MIL-C-60181(MU)
AMENDMENT 2
10 October 1967
SUPERSEDING
AMENDMENT 1
28 April 1967

MILITARY SPECIFICATION

CONTAINER, SHIPPING, REUSABLE: 10539223

This amendment forms a part of Military Specification MIL-C-60181(MU), dated 2 March 1965.

FIGURE 3 - SHELL, BODY

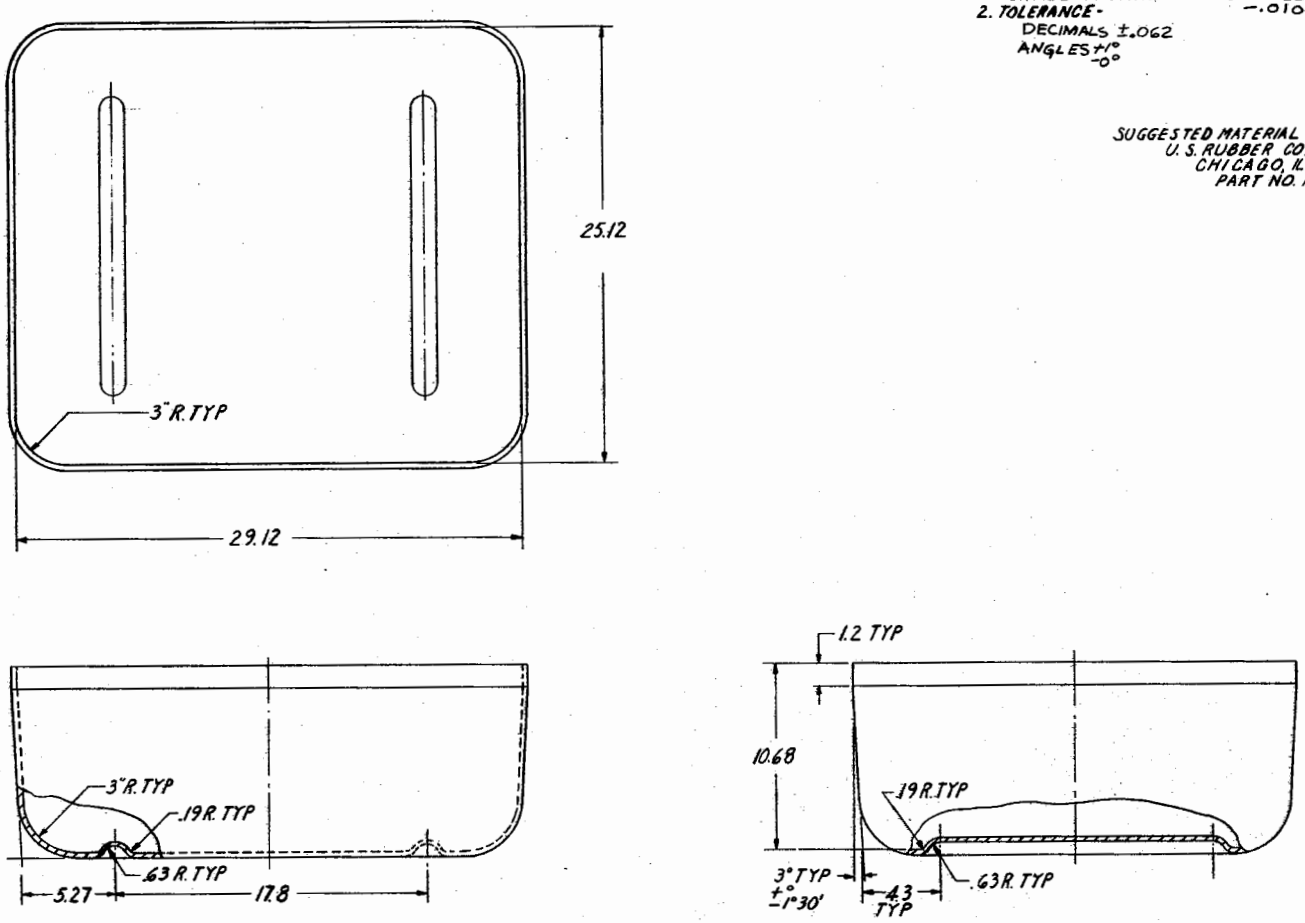
Delete: "Figures 3 and 4" and substitute attached "Figures 3 and 4."
